ADDENDUM
NO. 2

May 28, 2020

Additions & Renovations to Lawrence Central High School
7300 E.56th St.
Indianapolis, IN 46226

ADDENDUM NO. 2
MAY 28, 2020

A. Sheet Number SF1A1

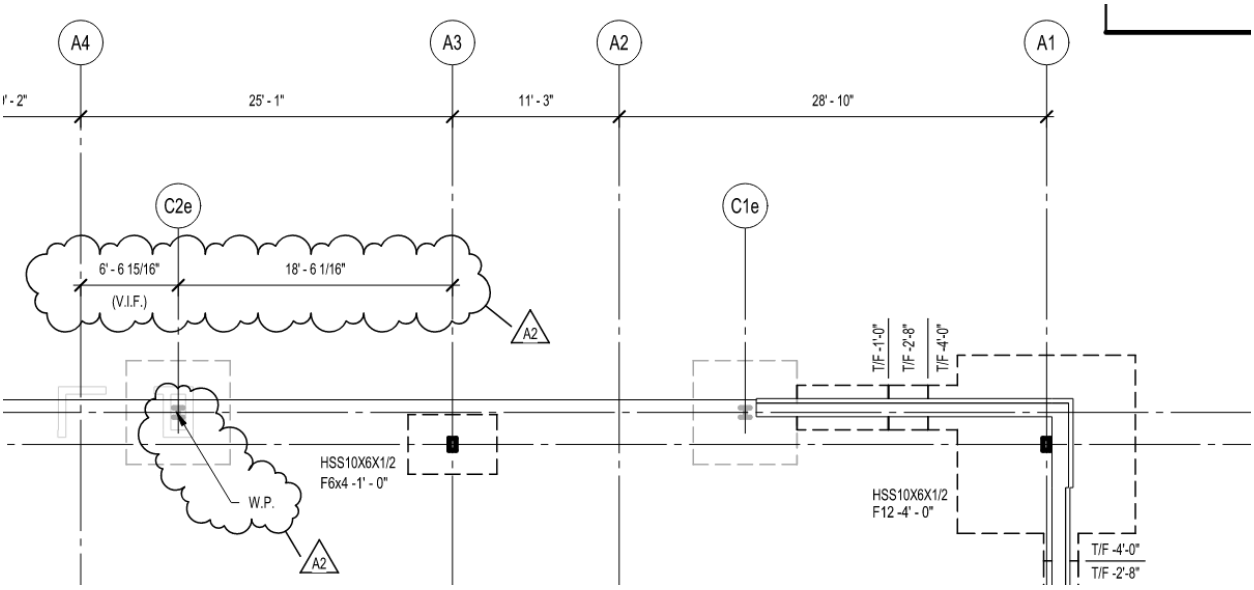
1. In 1/SF1A1, add workpoint dimensions from existing column CAe-C2e to new column AM-A3 as shown below.

C. Sheet Number SF1H1

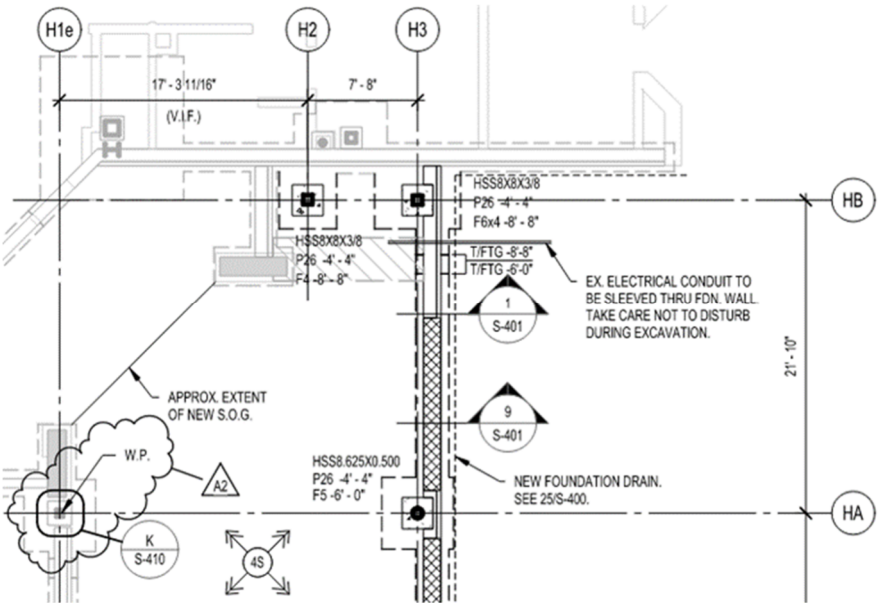
1. In 1/SF1H1, add callout designating existing column HA-H1e as workpoint for Unit H as shown below:

D. Sheet Number SF1K1

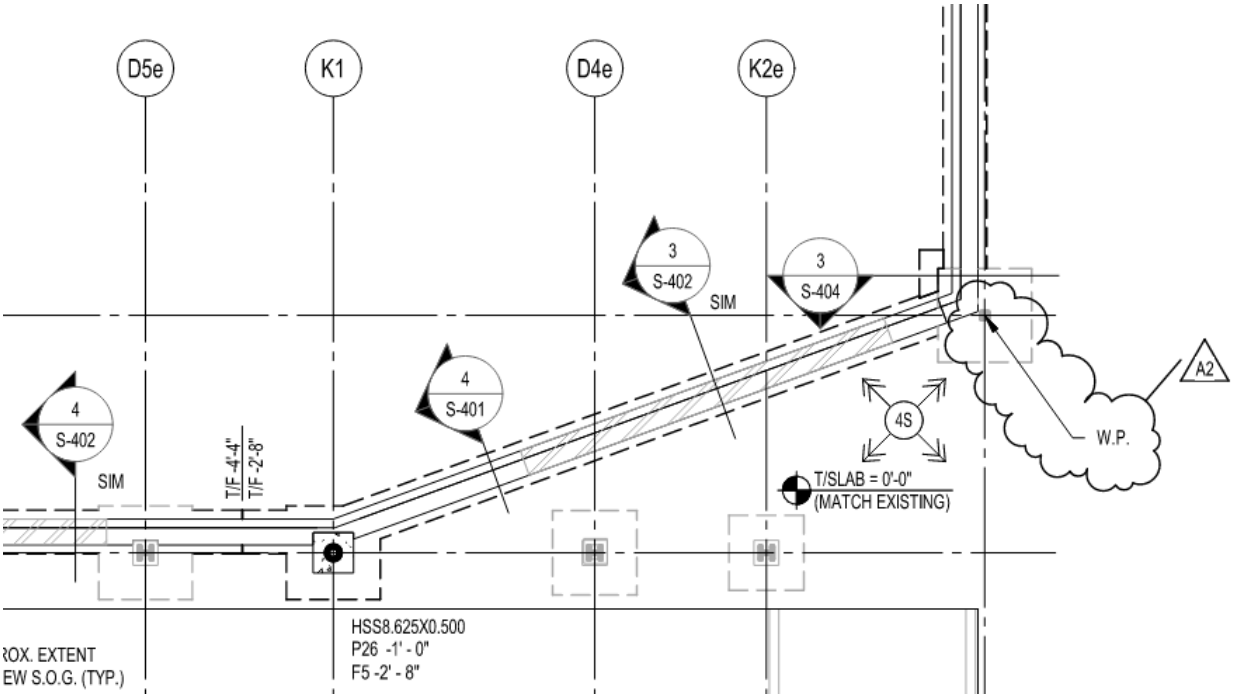
1. In 1/SF1K1, add callout designating existing column KDe-K1e as workpoint for Unit K as shown below:

E. Sheet Number SF1A2

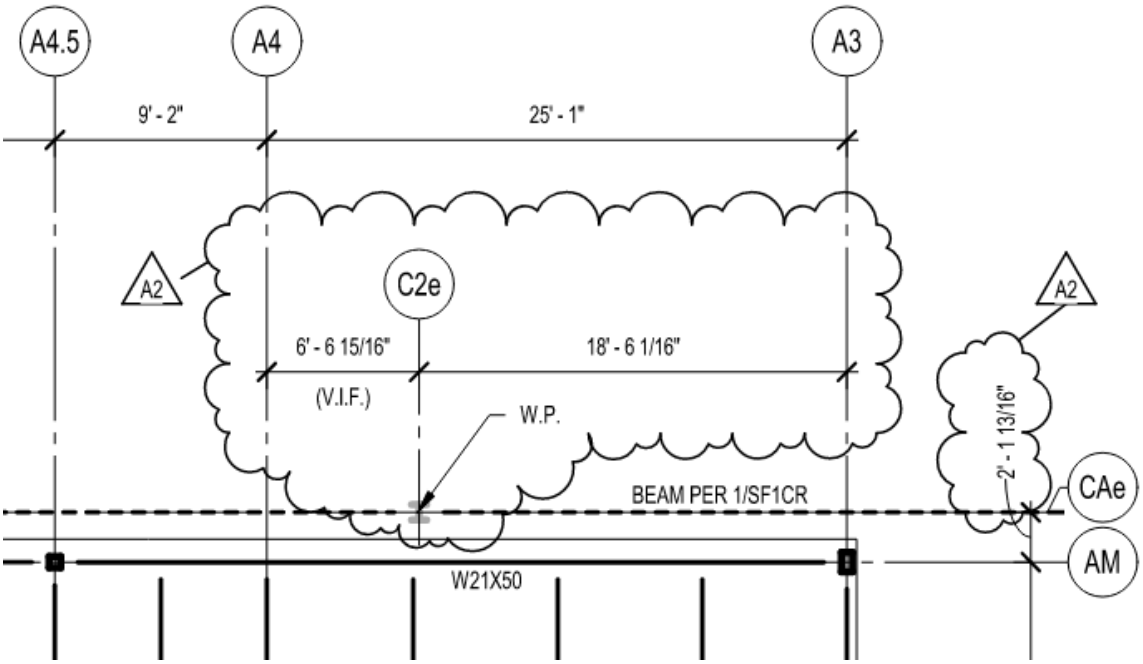
1. In 3/SF1A2, add workpoint dimensions from existing column CAe-A2e to new column AM-A3 as shown below:

F. Sheet Number SF1HR

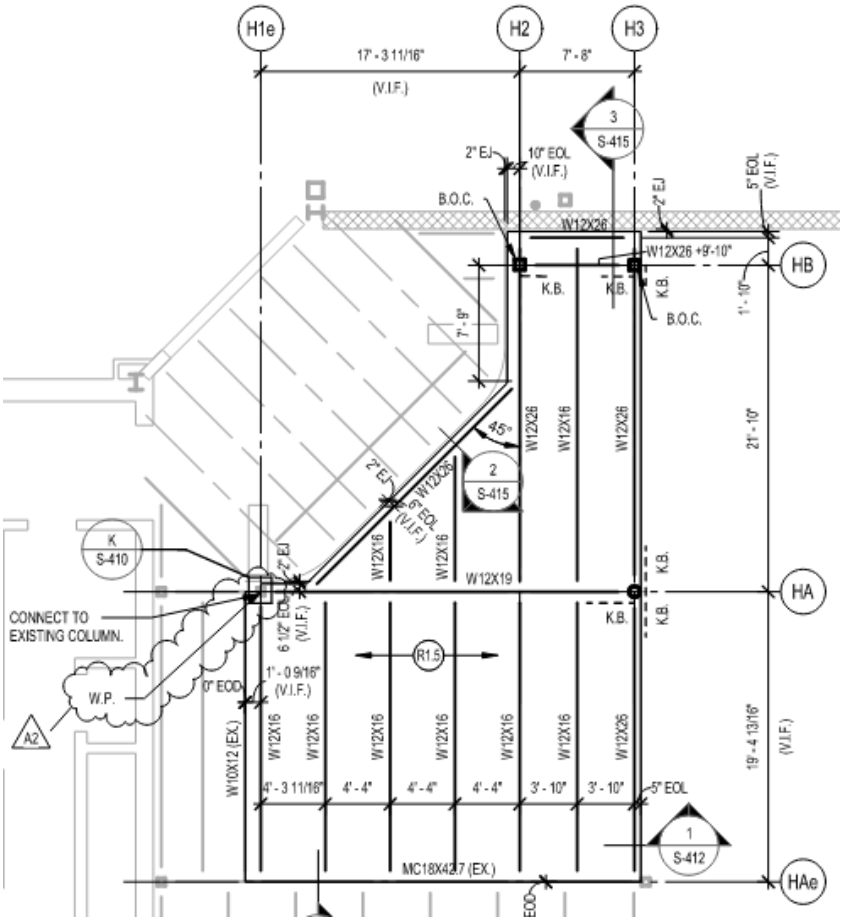
1. In 1/SF1HR, add callout designating existing column HA-H1e as workpoint for Unit H as shown below:

G. Sheet Number SF1KR

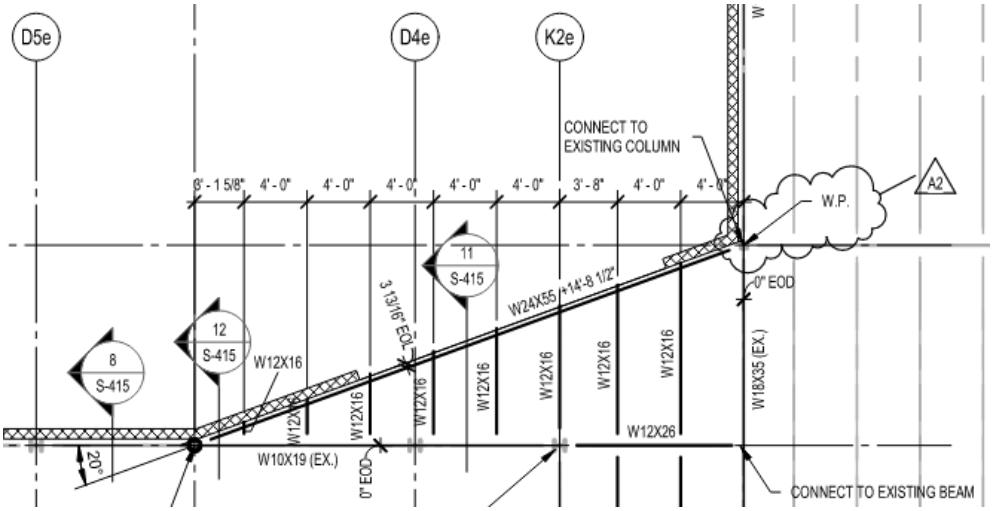
1. In 1/SF1KR, add callout designating column KDe-K1e as workpoint for Unit K as shown below:

B. Sheet Number AF1A1

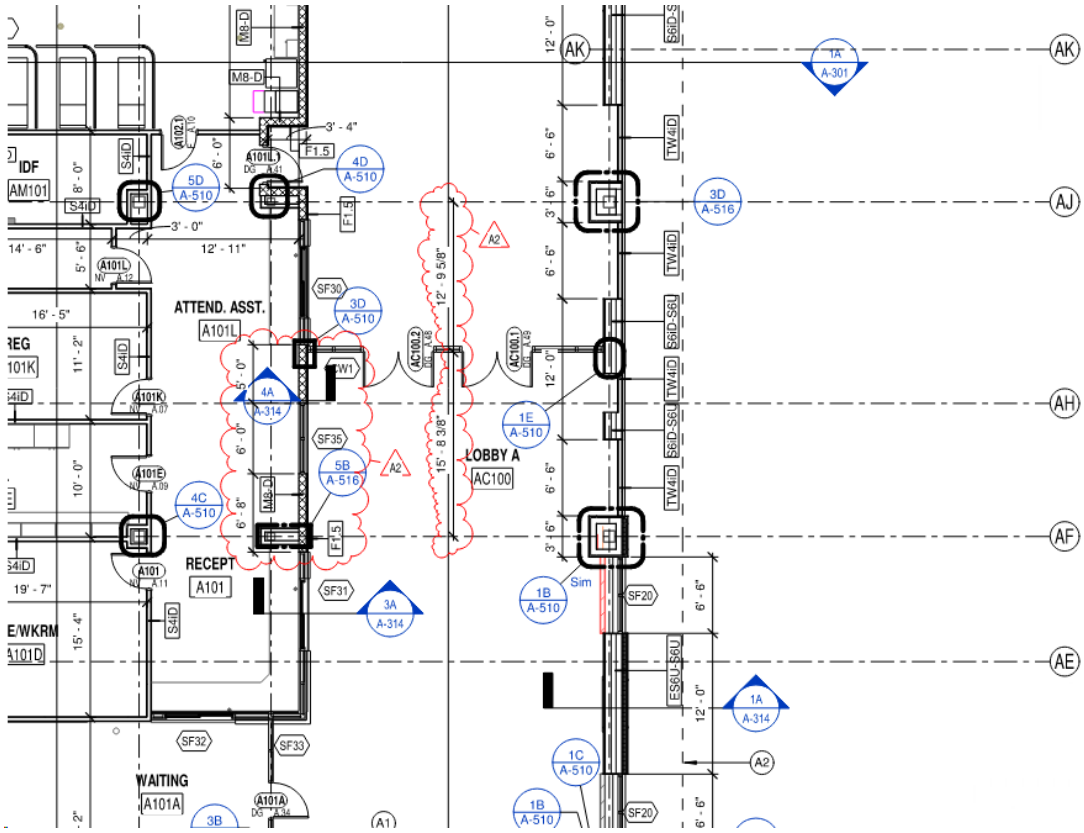
2. ADD storefront opening SF35 in Lobby AC100, and dimensions to CW1 location per the following:

C. Sheet Numbers AF1A1, AF1A2, and AF1A3

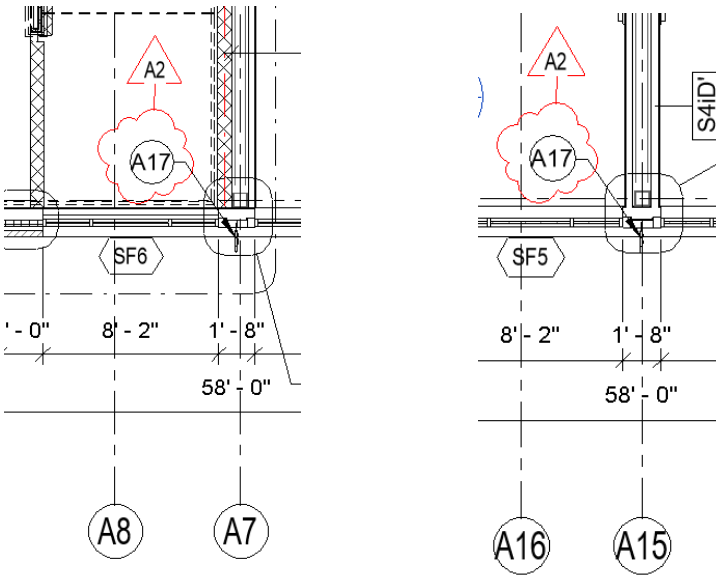
1. ADD Floor Plan Note A17 along the south exterior wall per the Drawings portions below:

D. Sheet Number AF1B1

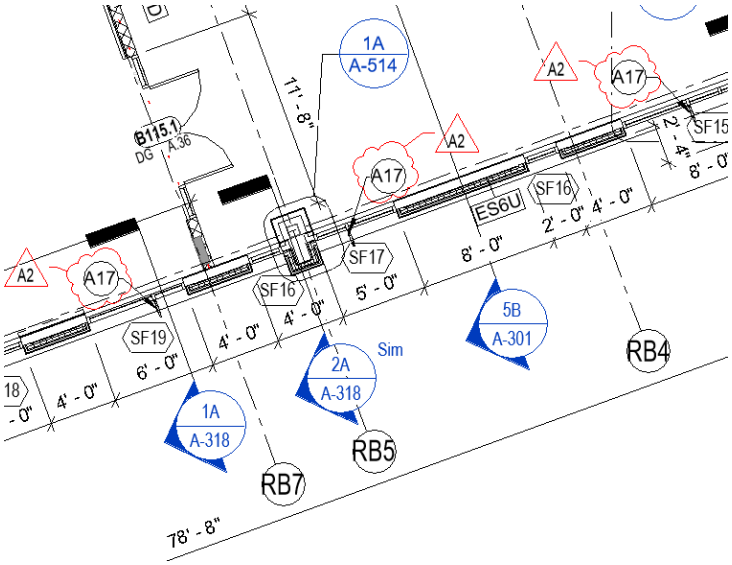
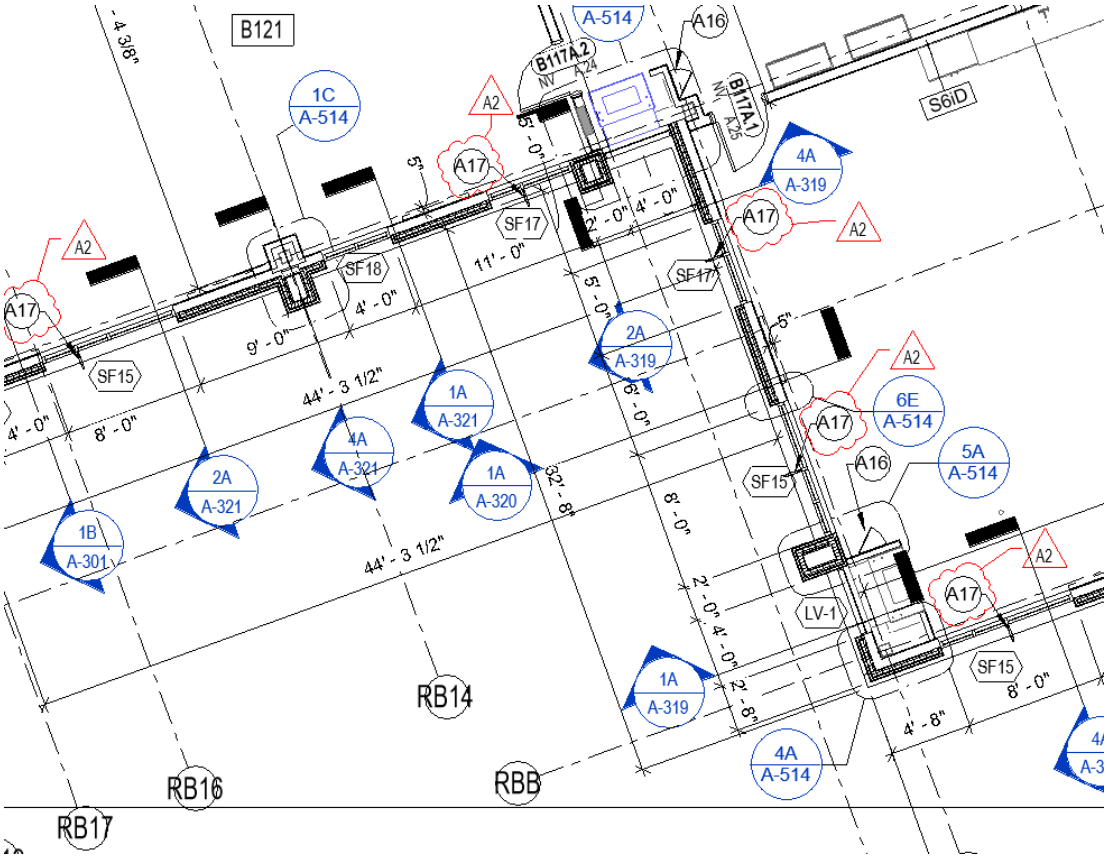
1. ADD Floor Plan Note A17 along south exterior wall segments of Science Rooms as indicated in the Drawings portions below:

E. Sheet Number AF1B2

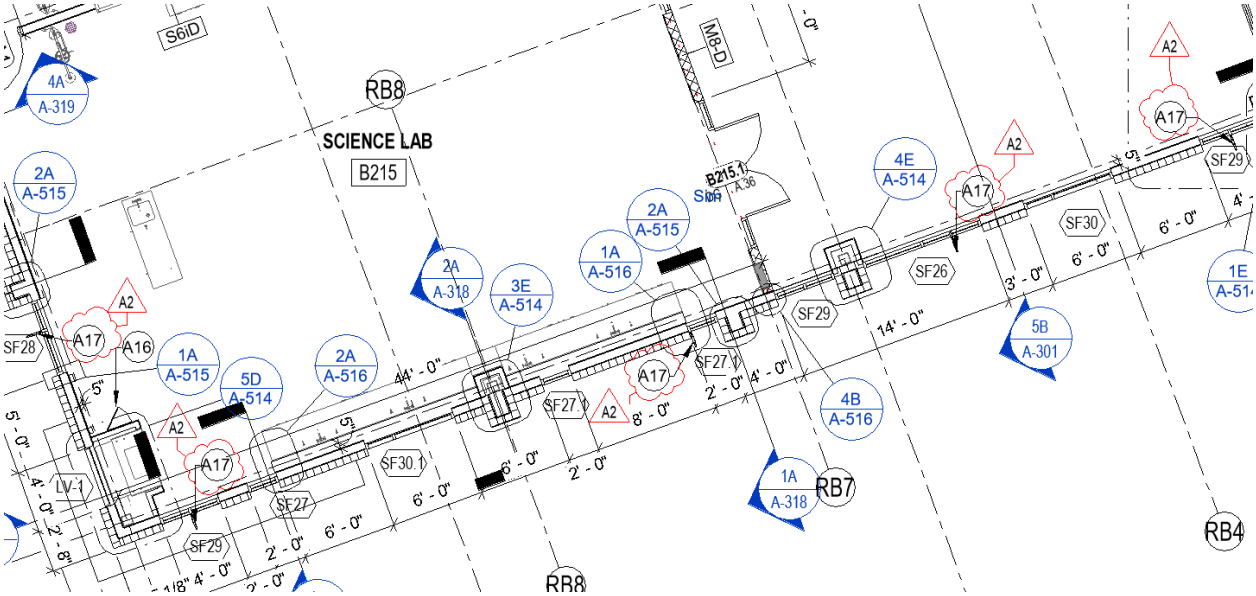
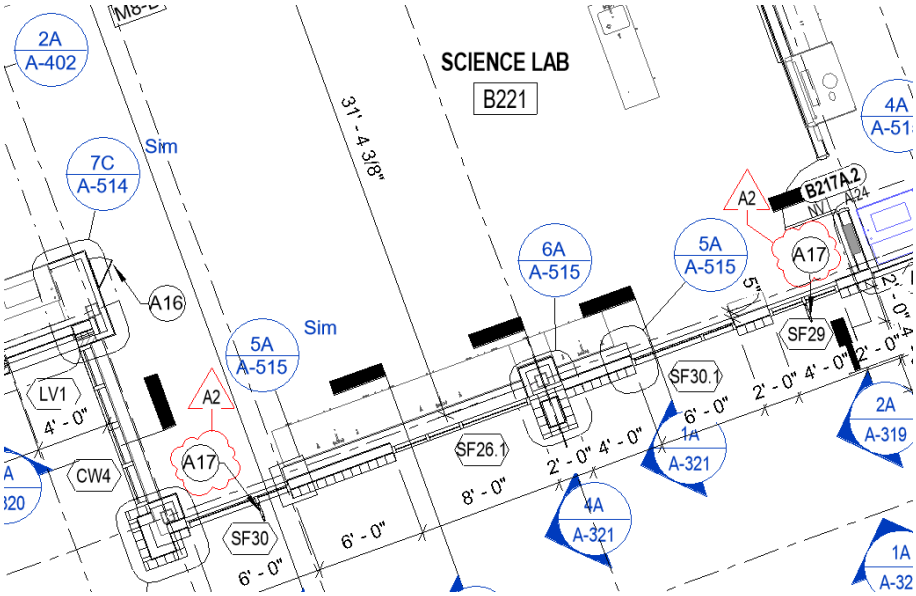
1. ADD Floor Plan Note 17 along the south exterior wall segments of Science Rooms as indicated in the Drawings portions below:

F. Sheet Number AF1B3

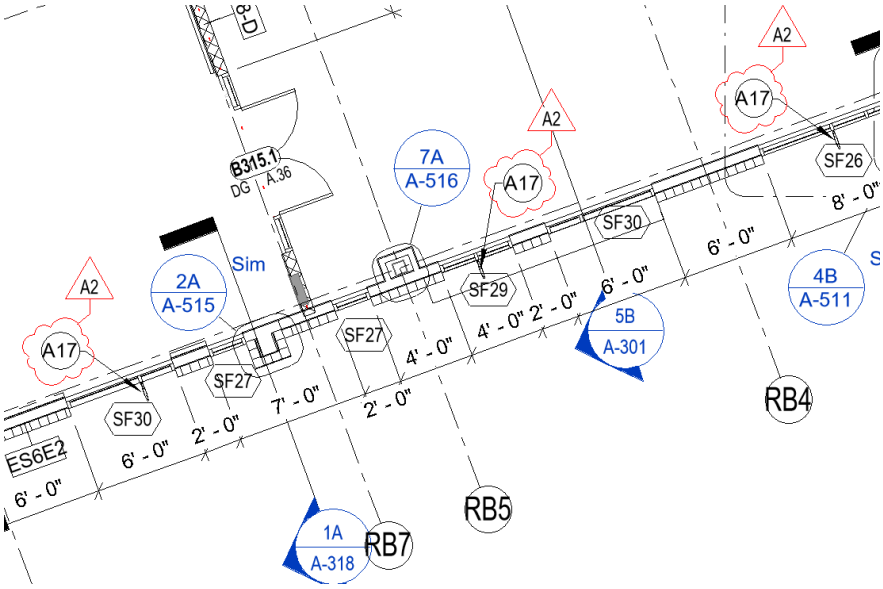
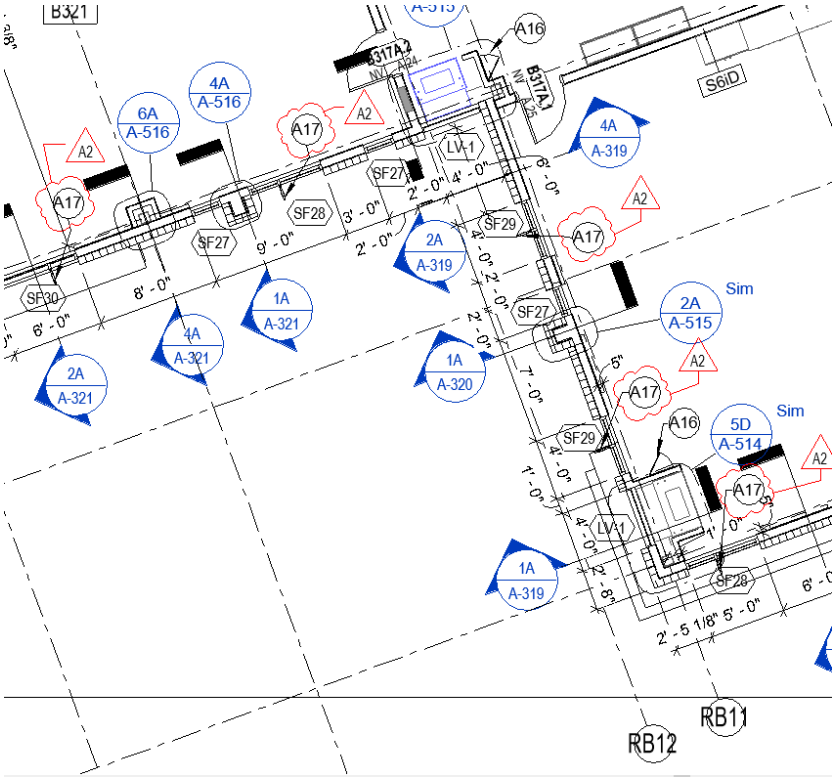
1. ADD Floor Plan Note 17 along the south exterior wall segments of Science Rooms as indicated in the Drawings portions below:

G. Sheet Numbers AF1B1, AF1B2, and AF1B3

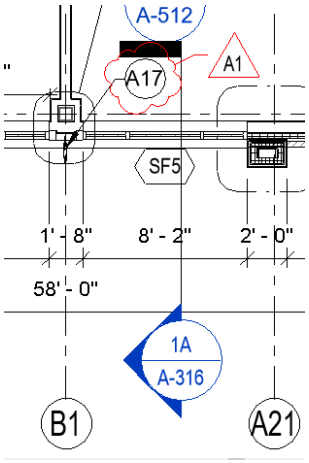
1. ADD Floor Plan Note 17 along the south exterior wall of Classrooms B113 and B111 as indicated in the Drawing portion below:

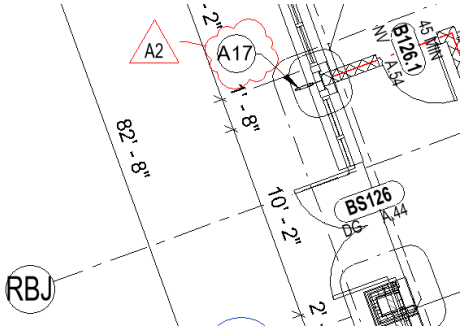
2. ADD Floor Plan Note 17 along the southwest exterior wall of Class B126 and Stairs B BS126 as indicated in the Drawing portion below:

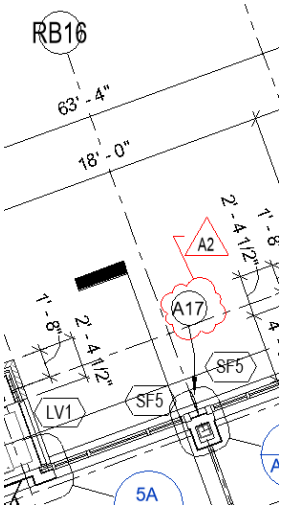
3. ADD Floor Plan Note 17 along the northwest exterior wall of Classrooms B124 and B126 as indicated in the Drawing portion below:

K. Sheet Number AC1D1

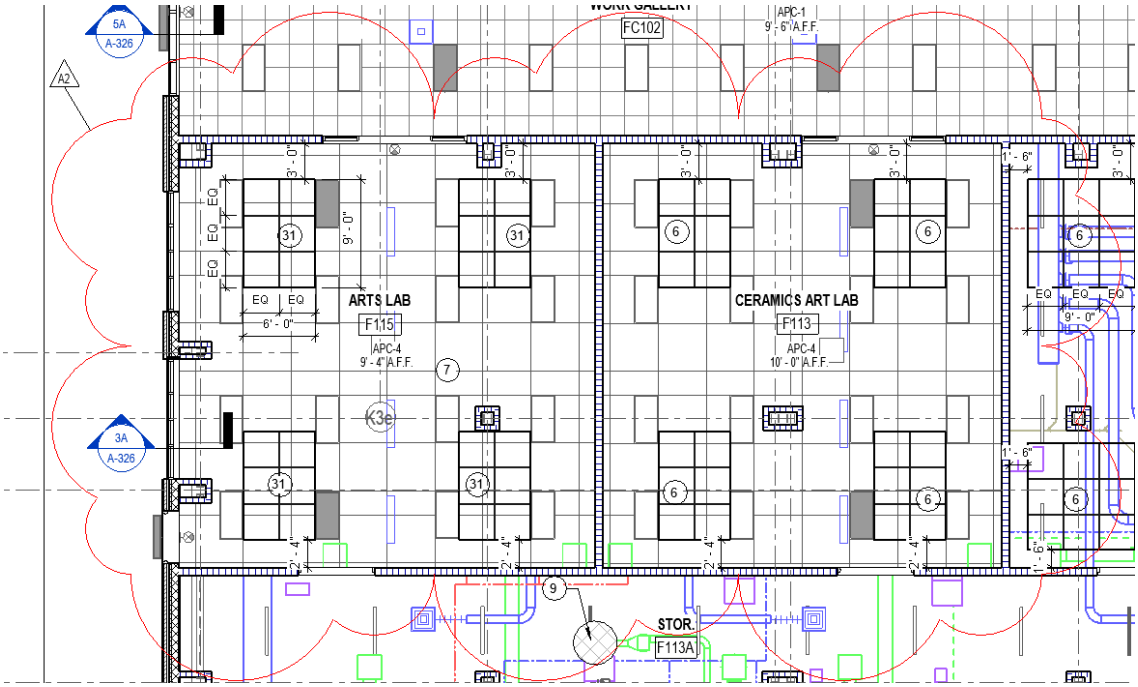
1. REVISE ceilings in Art Lab F115 and Ceramics Art Lab F113 as indicated in drawing below:
